PALO VERDE NUCLEAR GENERATING STATION, UNIT NO. 1

AMENDMENT TO FACILITY OPERATING LICENSE

Amendment No. 61
License No. NPF-41

AMENDMENT NO. 61 TO FACILITY OPERATING LICENSE NO. NPF-41

FIGURE 3.2-2

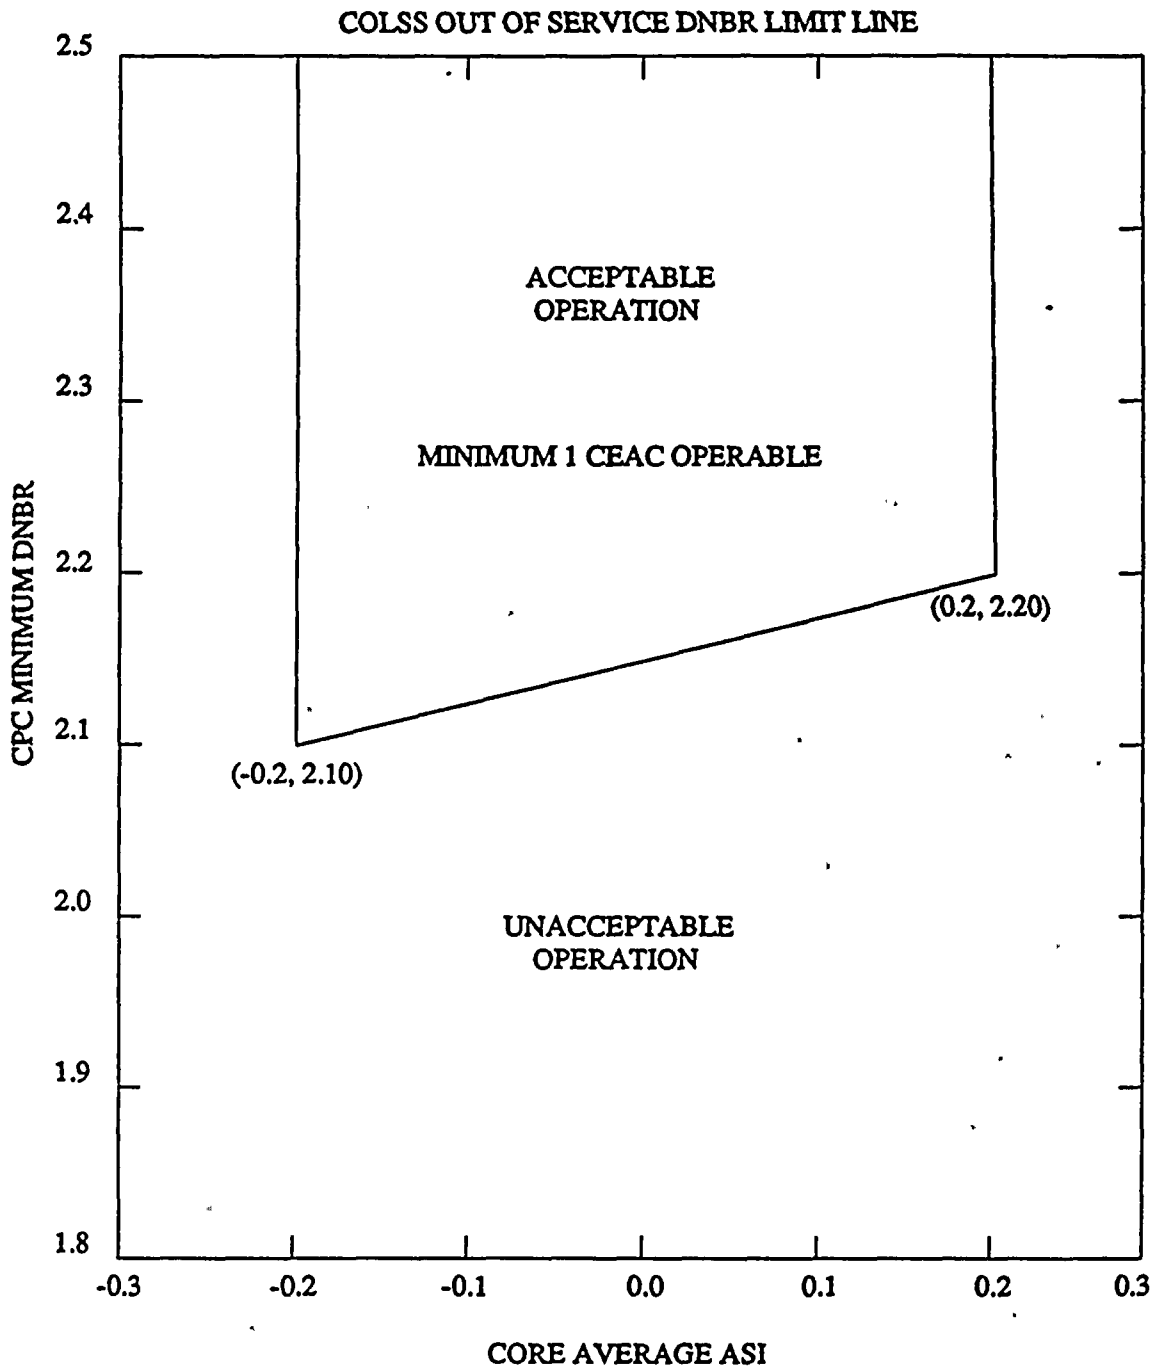
Replace the following pages of the Appendix A Technical Specifications with the enclosed pages. The revised pages are identified by amendment number and contain vertical lines indicating the areas of change.
